# MANDATORY SERVICE BULLETIN

NO. MSB 42-088/3

SUPERSEDES MSB 42-088/2

This Service Bulletin prescribes the inspection of the joints that connect the MLG (main landing gear) damper with the MLG trailing arm for cracks.

**D60-3217-21-00\_2  
D60-3217-22-00\_2**

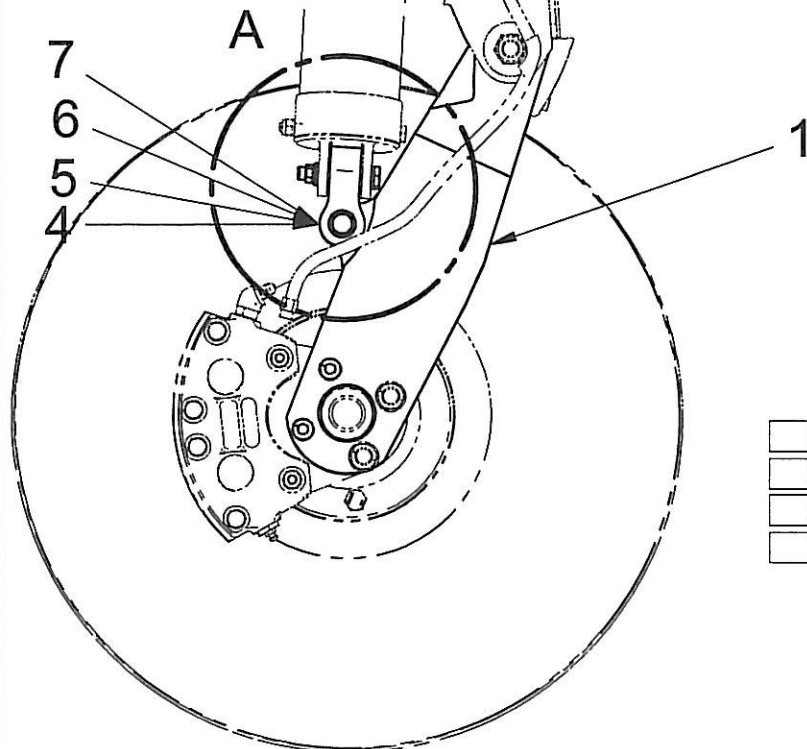
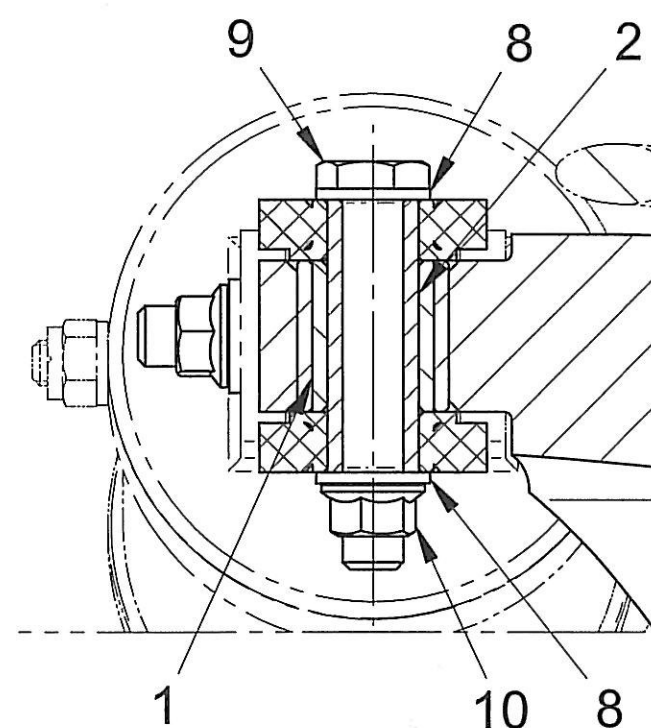
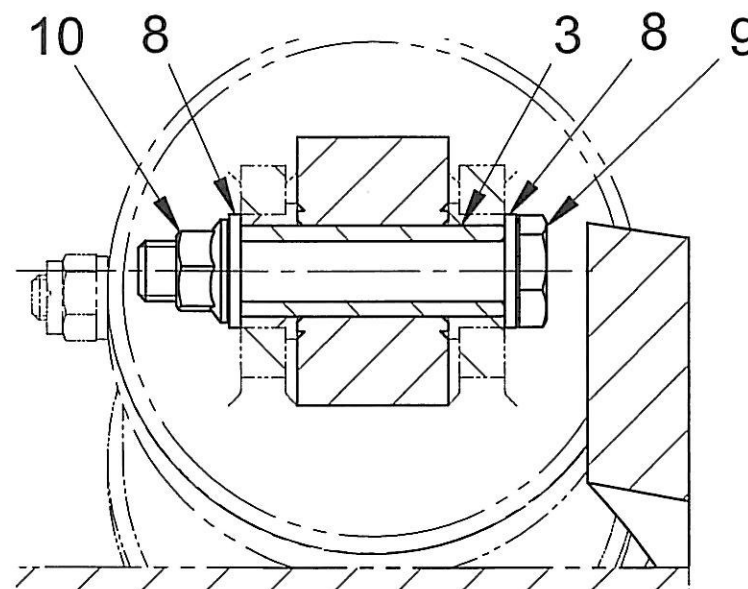
REVISION					
REV	SH	ZONE	DESCRIPTION	DATE	APPROVAL
-	01	ALL	MÂM 42-452 NEW DRAWING, DOES NOT SUPERSEDE ANOTHER DRAWING.	24.09.10	SEE TB
A	01	ALL	MÂM 42-452/b ITEM D60-3217-25-00 REPLACED BY D60-3217-41-00_1 FLAG NOTE 4 CANCELLED	18.11.10	SEE TB
